SERVICE BULLETIN

Service Bulletin No.: DAC1-79-02, Rev. 0

Title: Oil Filler Neck Bracket Installation

Figure 1

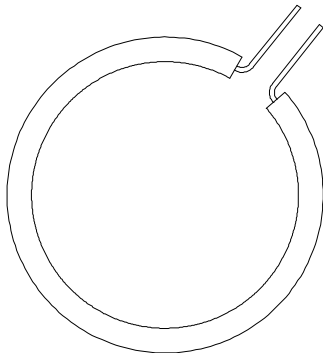
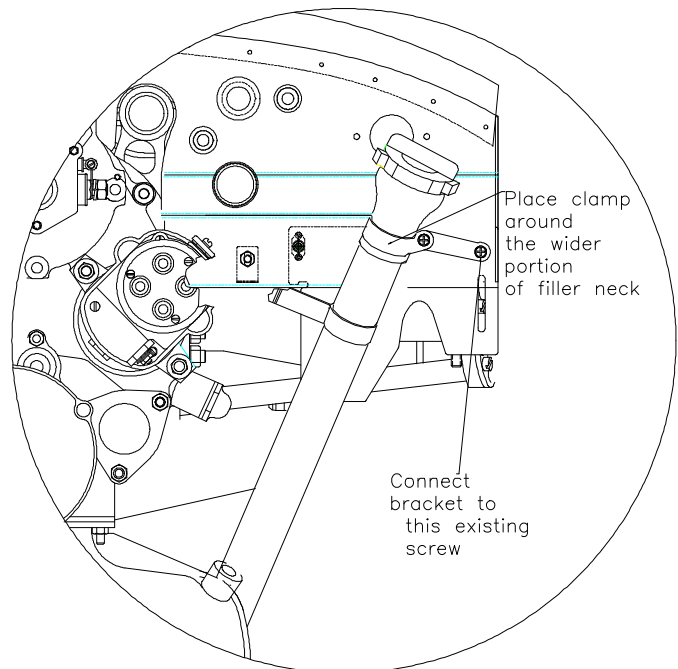
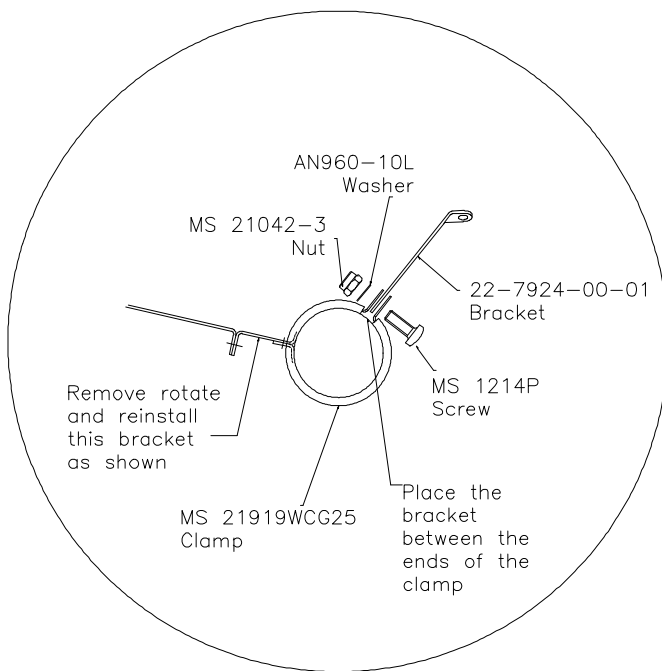
- 8. Special Tools:** N/A
- 9. References:** DA201-C1 Aircraft Maintenance Manual
- 10. Accomplishment Instructions:**
- 10.1** Remove, rotate 180° and re-install the existing oil filler neck bracket. Orient the hardware as it was removed (some engines may already have this accomplished). Reference Figure 1.
 - 10.2** Form P Clamp and install additional support bracket as shown in Figure 1. The bracket attaches to the existing screw that connects the side baffle to the aft baffle.
- 11. Weight and Balance:** This service bulletin does not affect the aircraft's weight and balance.
- 12. Availability:** Contact Diamond Aircraft Parts Department.
